## HISTORIC PRESERVATION COMMISSION

### MEMORANDUM

SUBJECT: Historic Area Work Permit #1018710: Hardscape alteration, fence installation, and driveway alteration

Applicant: Josh Harrison and Jamillia Ferris (Phillip Long, Agent)  
Address: 9 West Kirke Street, Chevy Chase

**FENCE PLAN**  
**LS120**

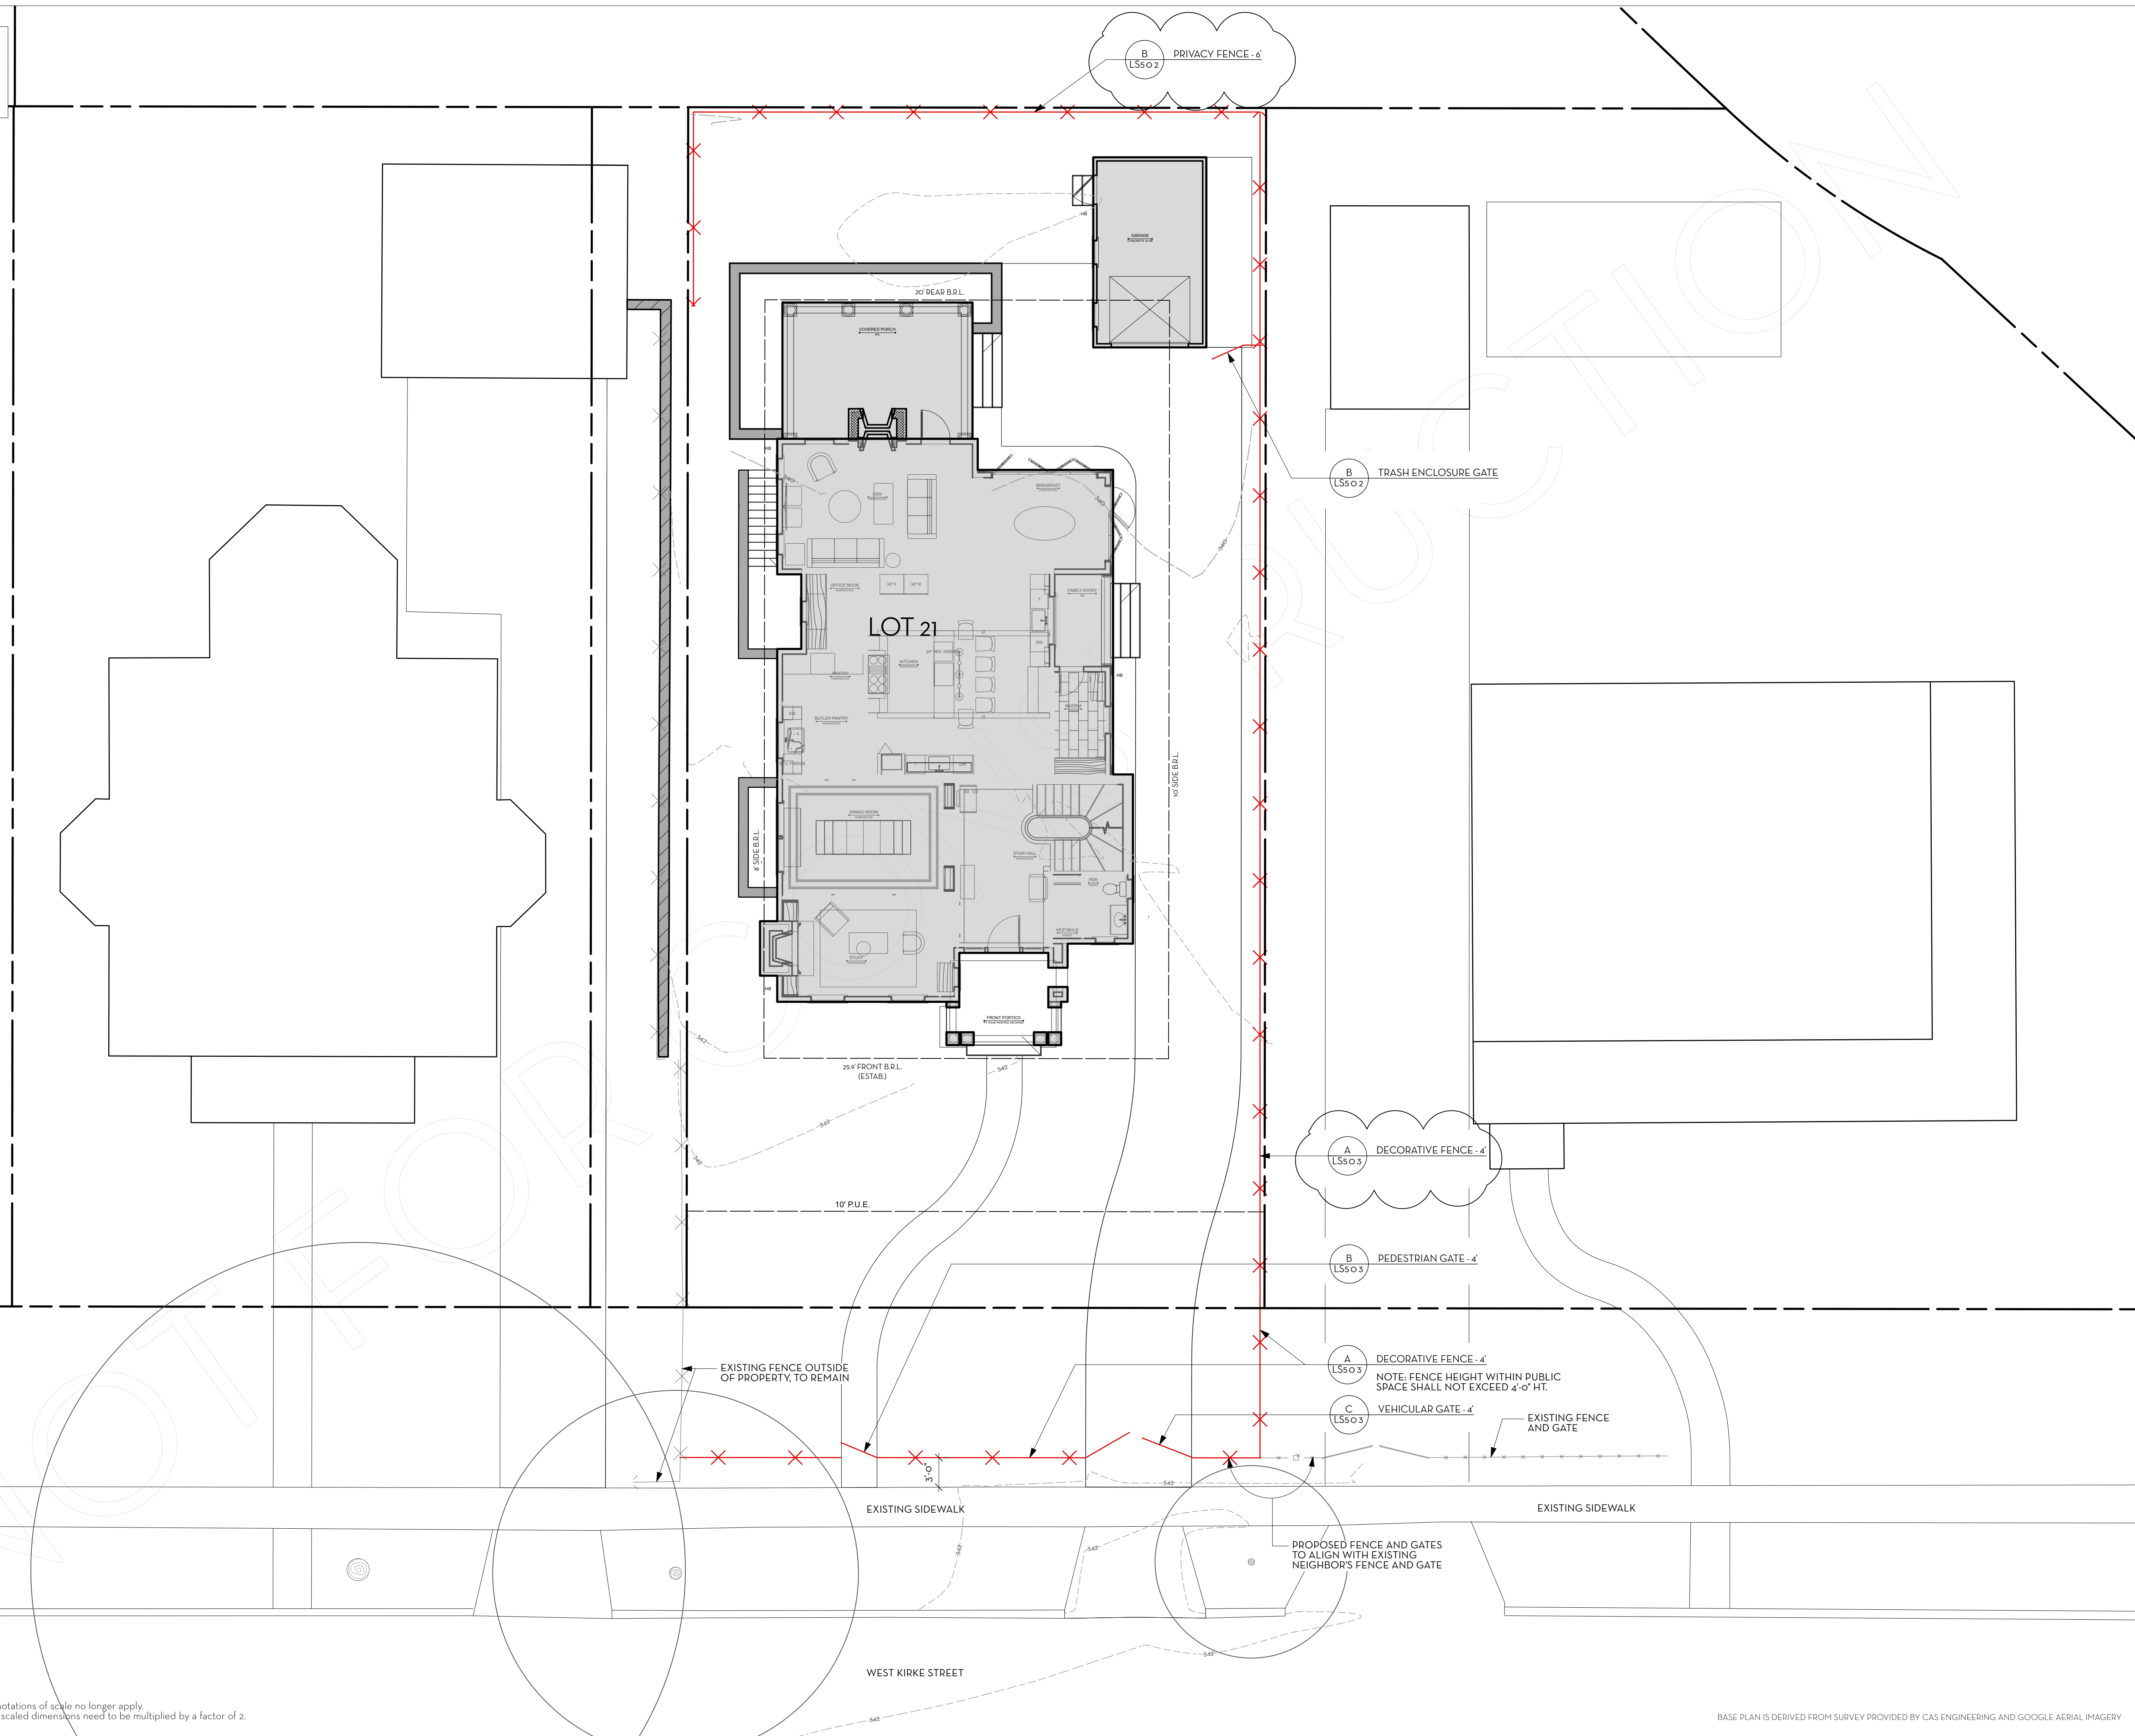
- 1. The proposed fencing along the right side of the property will transition from 6' privacy fencing to 4' picket fencing at the approximate rear of the house, with final review and approval delegated to staff.**
